Subject: DOORS DO NOT LOCK / UNLOCK WHEN USING DOOR REQUEST SWITCH	Bulletin No: 09-038/15
	Last Issued: 09/22/2015

2007-2015 CX-9 vehicles equipped with advanced keyless entry system

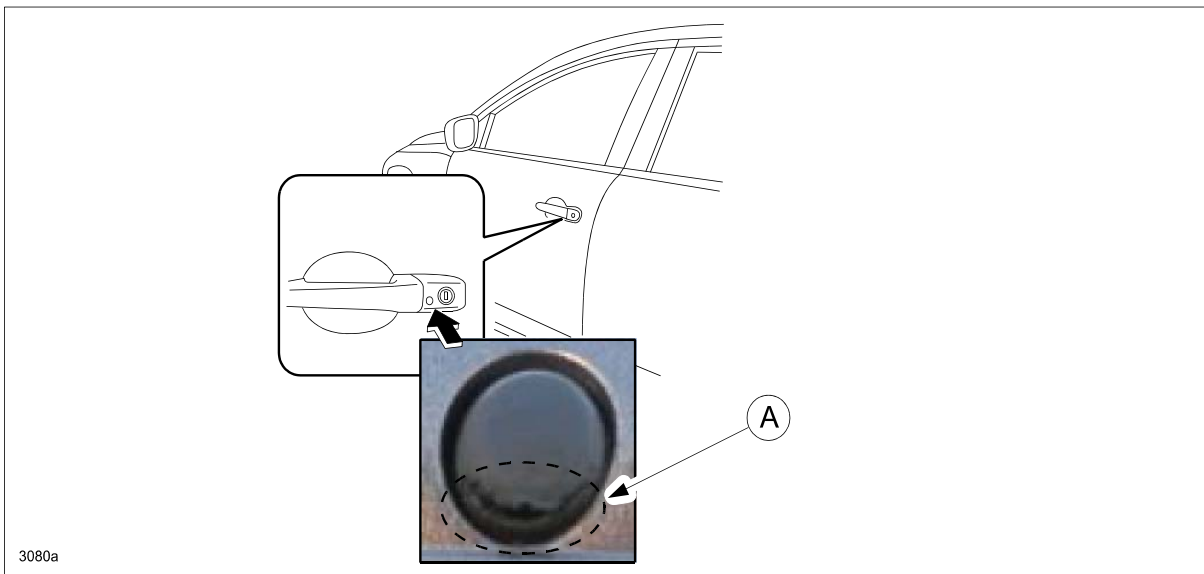
Some customers may complain that the doors do not lock / unlock when pressing the request switch. This may be caused by a torn or cracked request switch rubber button (A).

The rubber surface of the request switch may become gradually worn out by repeated use. Water may enter the request switch and cause a short-circuit of the electrical system.

To eliminate this concern, the thickness of the rubber button has been increased from 0.6 mm to 1.8 mm to improve wear resistance.

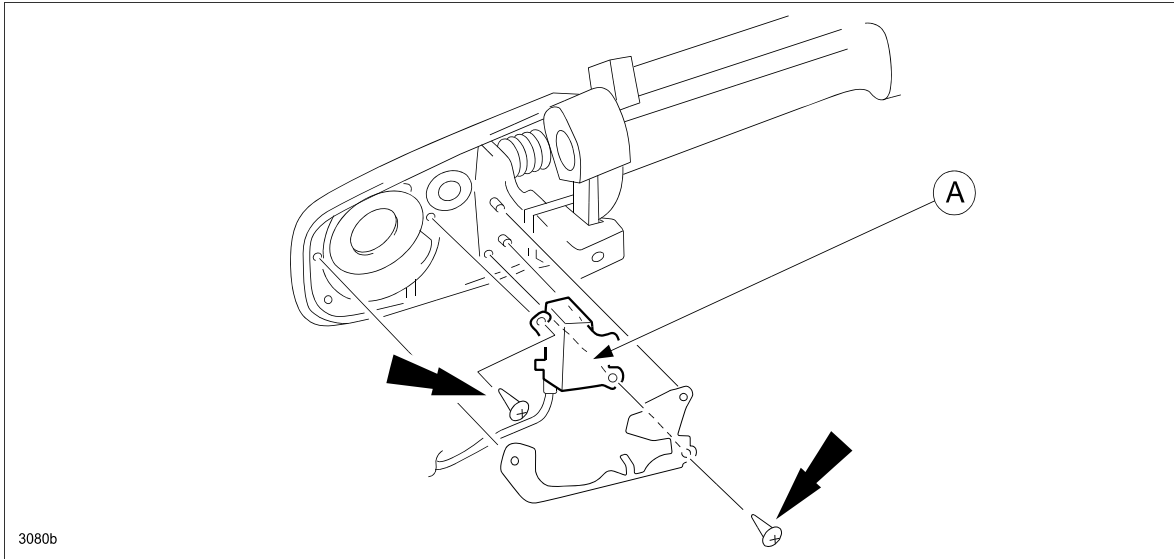
1. Verify the customer concern by inspecting the request switch rubber button for damage.
 - If the rubber button is torn or cracked, proceed to Step 2.
 - If the rubber is not broken, this bulletin does not apply. Proceed to the instructions on MS3 online or the Workshop Manual for further troubleshooting information.
2. Replace the affected side request switch (A) with a modified part according to the instructions on MS3 online or the Workshop Manual (section 09-14 REQUEST SWITCH REMOVAL/INSTALLATION [ADVANCED KEYLESS ENTRY AND START SYSTEM]).
